Cornerstone of Centerville Phase 4 Public Improvements Centerville, Ohio 45440

BID ADDENDUM No. 2

Cornerstone of Centerville, North **Phase 4 On-Site Public Improvements**

Addendum Issued:	Monday, Januar	ry 27, 2020 at or befo	re 5:00 P.M.
------------------	----------------	------------------------	--------------

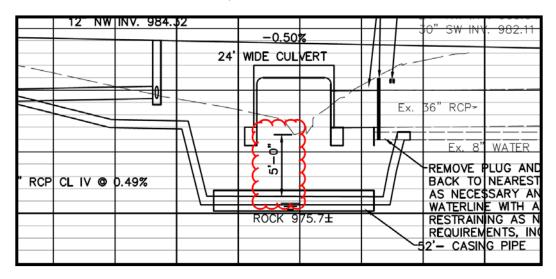
Revision No. 1: The Ohio EPA is requiring 5'-0" of cover over the water line at the stream crossing, versus 4'-6". Sheet 31 of 61 has been revised to note 5'-0" of cover as captioned below and attached hereto.
